## **APPENDIX D**

### **Time Concentration Plots for Water Quality Tracking Wells**

The Basin A Neck System (BANS) and Bedrock Ridge Extraction System (BRES) were installed to extract the contaminated groundwater flowing out of former Basin A and treat it to meet remediation goals at the BANS treatment plant. The migration pathways to these systems were the only known outlets for contaminated groundwater migrating from former Basin A. As discussed in Five-Year Summary Report (FYSR) Section 5.1.5.1, a migration pathway at the north end of former Basin A was identified for dieldrin and arsenic in the 2014 on-post plume mapping project.

Figure 4.24

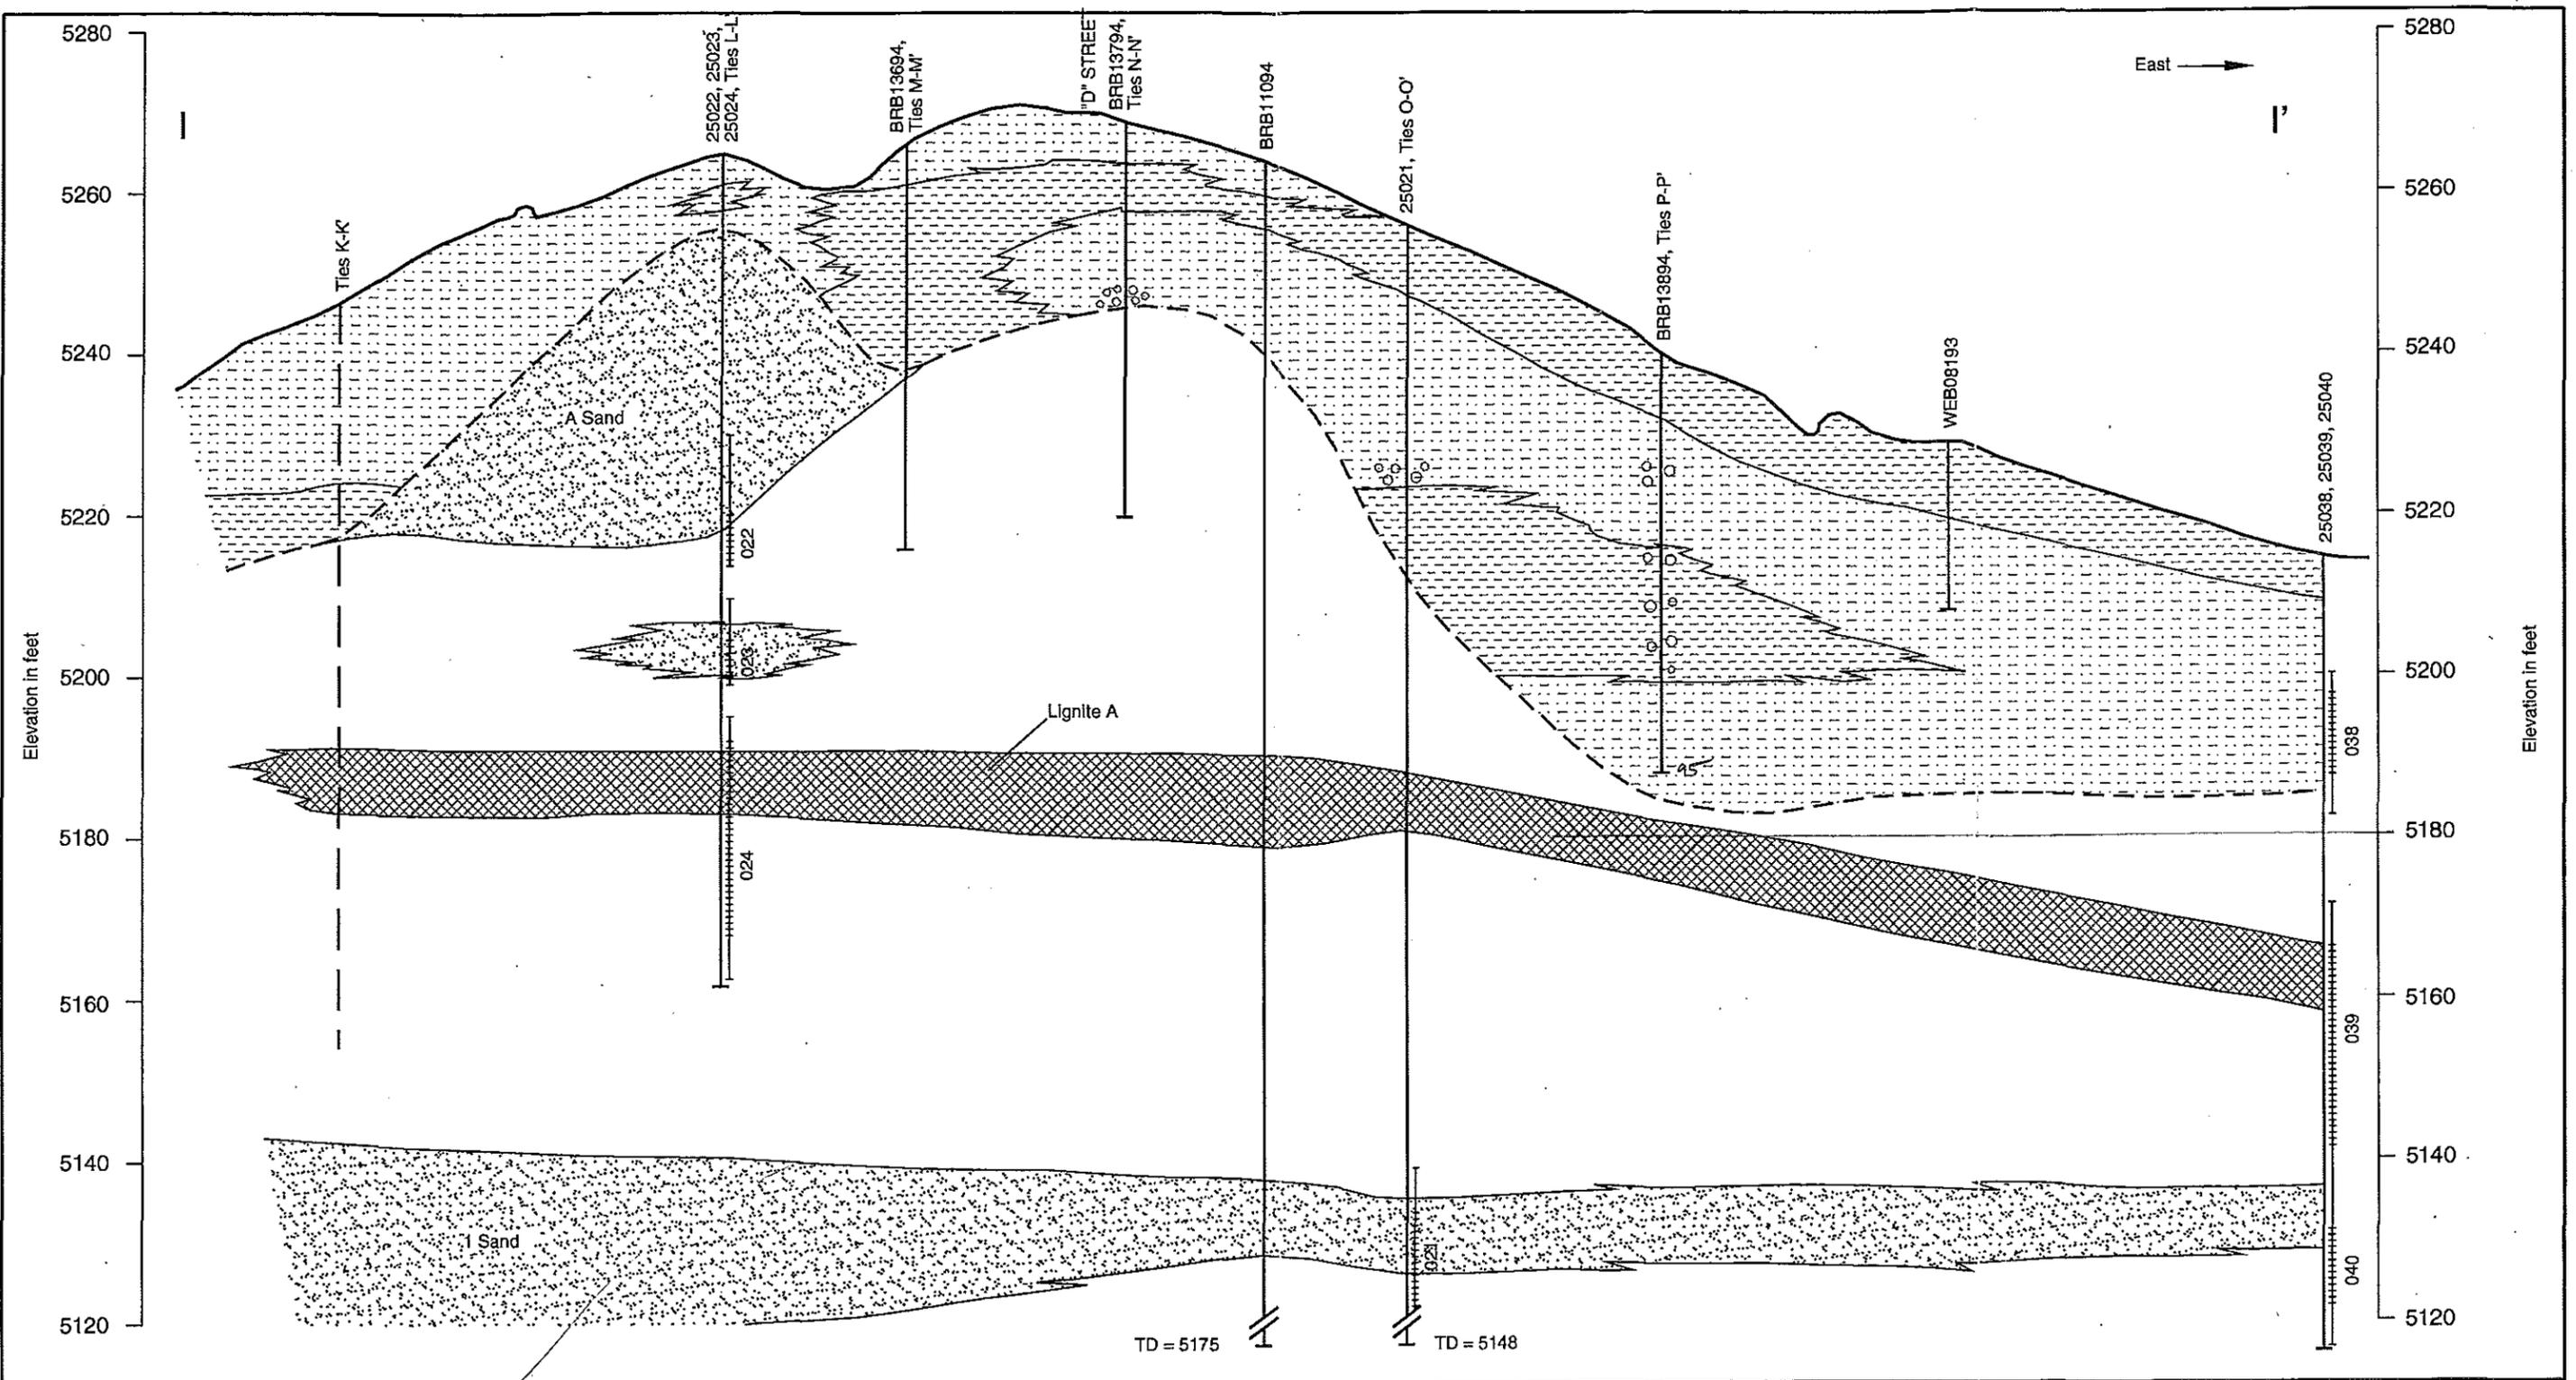
Cross sections I-I' (Figure 4.24) and L-L' (Figure 4.26) from the HLA report show the east-west and north-south extents, respectively, of the A Sandstone present in well 25022. Wells 26500 and 25106 were added to cross-section G-G' from the MK report to better define the extent of the A Sandstone. The A Sandstone is absent near well 25106 and the zone screened in well 25106 is correlative to the zones screened in well 25023 and the upper portion of well 25024 (upper portion of Lignite A) shown on the three cross sections.
